### FLUCTUATION OF TEMPERATURE ON NOFROST

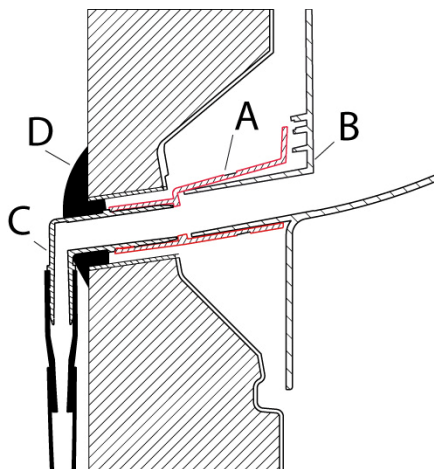
If the freezer has fluctuation of temperature, the reason is that the fan may jam. The service action for appliances up to serial no 825 is to change the fan cpl. The metal plate in the nofrost module should also be pressed down against the bottom, by using AL-profile 208 76 15-01, (se picture) to prevent ice accumulation, valid for appliances up to serial no 837.

When reassembling the module, check that the rubber draining sleeve at the outlet (A) is not loose from the module (B). Check also that the plastic part of the draining hose (C) is pressed against the module and fits into the rubber draining sleeve. Tighten carefully with sealing compound (D) (see picture).

Fan cpl according to the spare parts list and the AL-profile 208 76 15-01 can be ordered from Distriparts.
